516F-2 AC POWER SUPPLY (522-1170-000)

SERVICE INFORMATION LETTER 1-76

PREVENT FUSE BLOWING CAUSED BY ARCING IN THE VACUUM TUBE RECTIFIERS

CR2, 3, 4, 5 Mounting Location
Figure 1

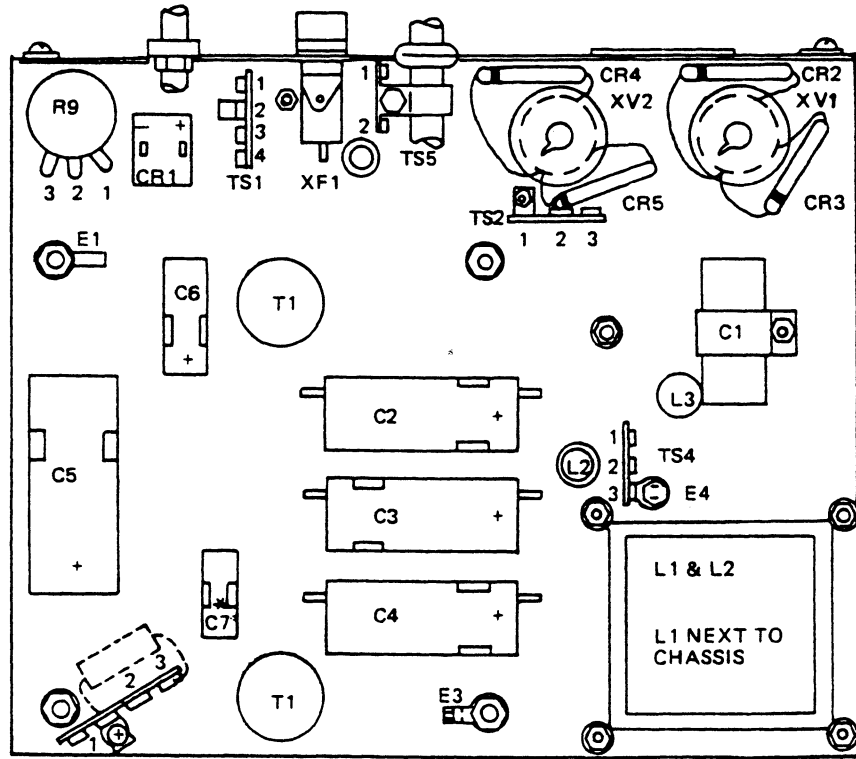
A few problems have been reported from the field concerning blown fuses in the 516F-2 power supply. Investigation has shown that the cause of the problem is arcing in rectifier tubes V1 (5R4GYA) and V2 (5U4GB). However, most of these tubes are performing satisfactorily so this service information letter is intended only for those power supplies that have a fuse blowing problem.

Vacuum tubes V1 and V2 should be removed and Semtech SCH-5000 solid state diodes (CPN 353-0425-010) should be installed as follows.

<u>DIODE</u>	<u>FROM</u>	<u>TO</u>
CR2	XV1-8 (cathode)	XV1-4
CR3	XV1-8 (cathode)	XV1-6
CR4	XV2-8 (cathode)	XV2-4
CR5	XV2-8 (cathode)	XV2-6

Figure 1 shows the diode locations pictorially and figure 2 shows the circuit change schematically.

This change will increase the output voltage to the KWM-2/2A and 32S-() transmitters by approximately 12 percent. The respective bias must be adjusted using the transmitter instruction books as a guide. It is recommended that the transmitter final amplifiers be kept at resonance at all times and that the swr always be less than 2:1.
